# BARBARICK RECYCLING AND REFUSE TRANSFER STATION

CONSTRUCTION DOCUMENTS  
MARCH 2024

BARBARICK WASTE TRANSFER STATION  
EL PASO COUNTY, COLORADO  
CONSTRUCTION DOCUMENTS  
COVER SHEET

BARBARICK WASTE TRANSFER STATION  
EL PASO COUNTY, COLORADO  
CONSTRUCTION DOCUMENTS  
OVERALL SITE PLAN

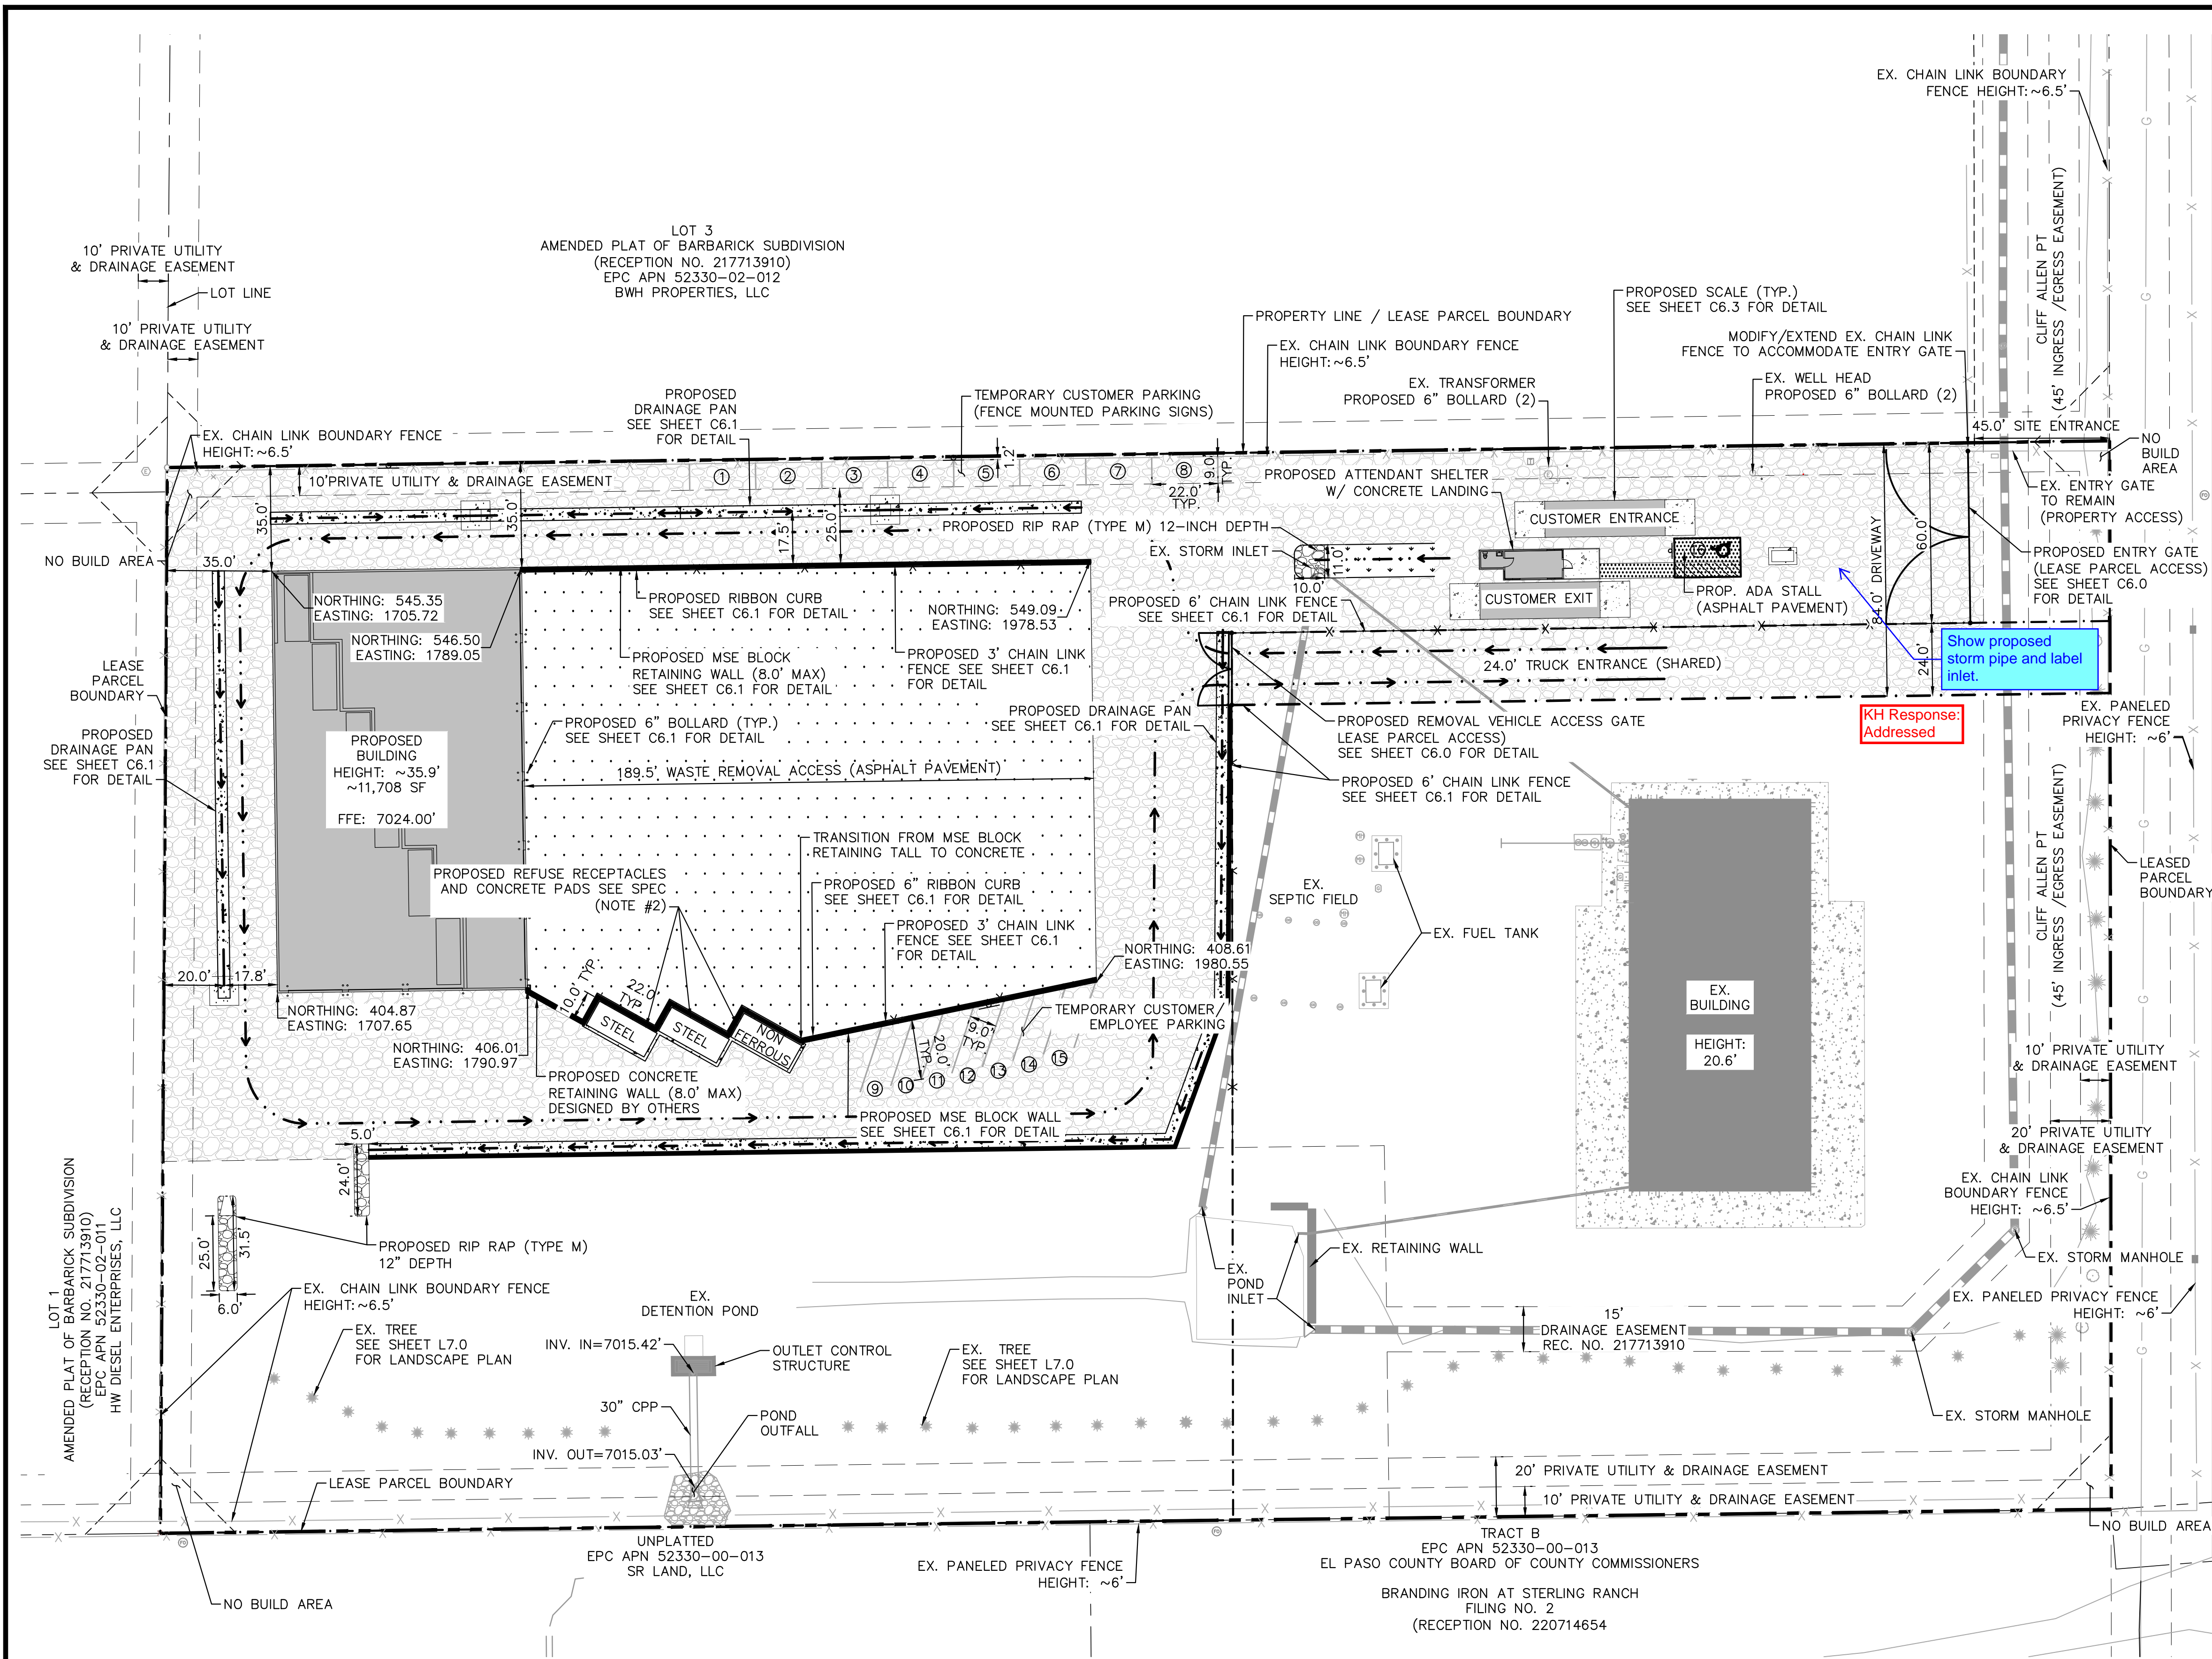
Show proposed storm pipe and label inlet.

KH Response: Addressed

BARBARICK WASTE TRANSFER STATION  
EL PASO COUNTY, COLORADO  
CONSTRUCTION DOCUMENTS  
STORM PLAN & PROFILE

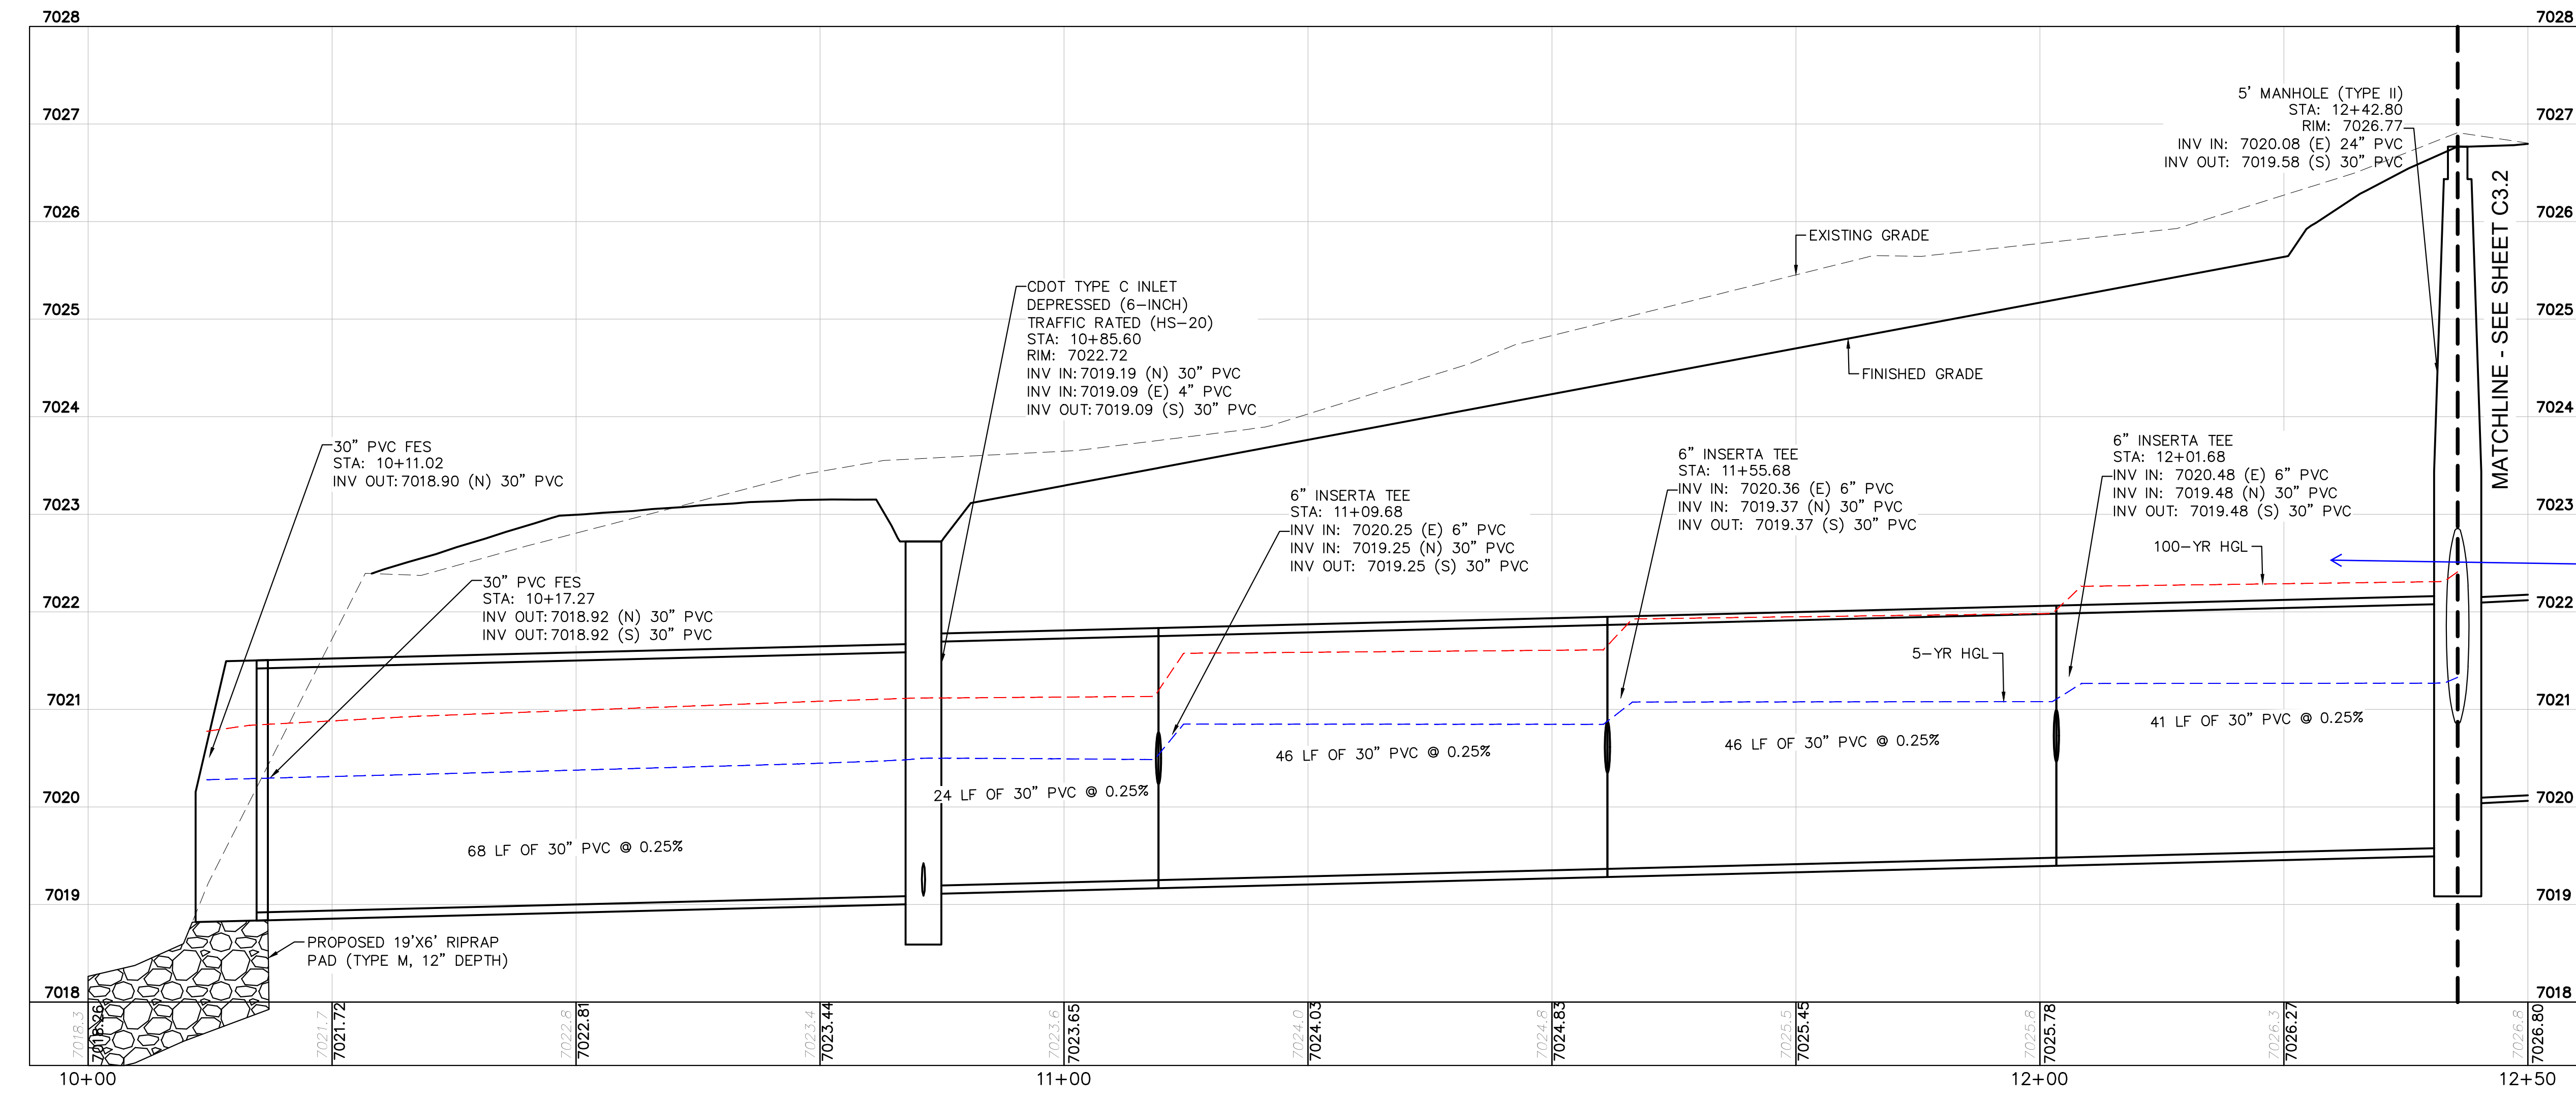
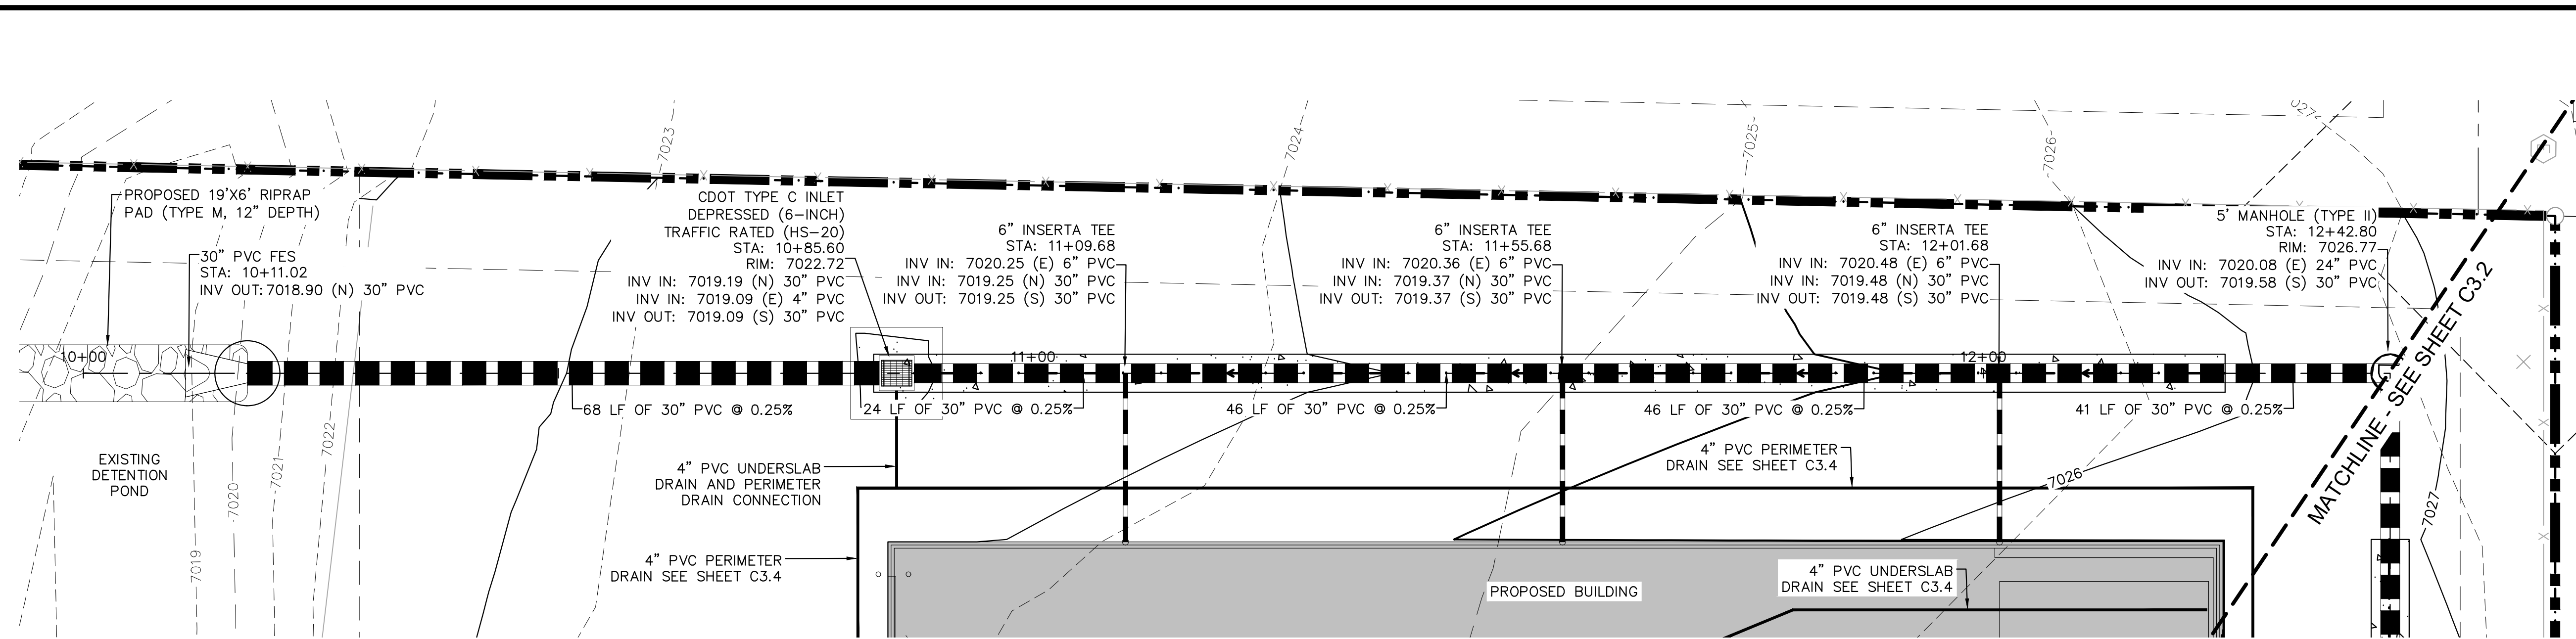
Please add the following note to the CD where applicable  
"Add water tight joint when 100 YR HGL shows pipe fully inundated"

KH Response: Addressed
